Product Bulletin

30013A01

Easier Recognition of MKII Valve Inserts and Guide Discs (without Safety Pressure)

LIDINGÖ May 25, 2008

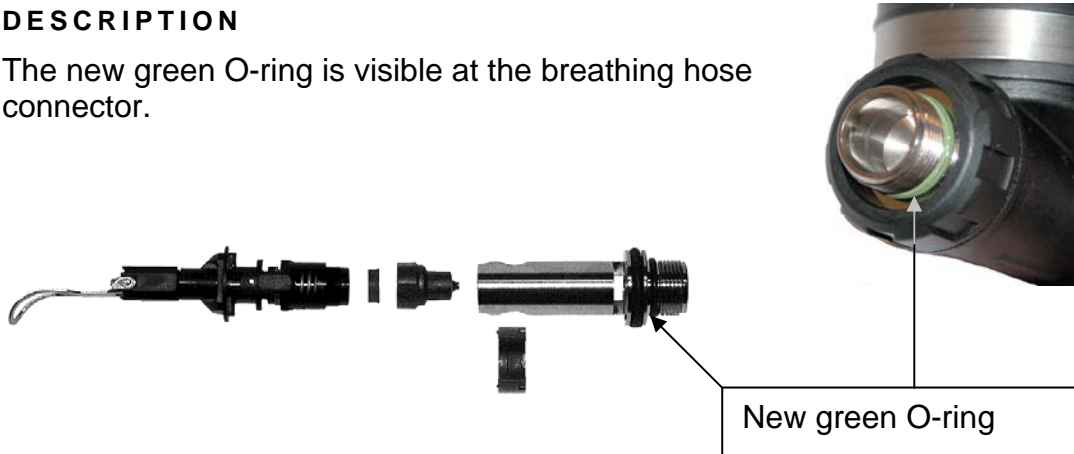
To ensure easier recognition of breathing valves **without safety pressure**, the black O-ring at the end of the connection nipple has been replaced with a green O-ring.

Similarly, the Guide disc 460 190 412 (for the Sealing spring, 460 190 500), has been fitted with a hole to recognize more easily that the spring assembly is made for a breathing valve **without safety pressure** (see illustration below).
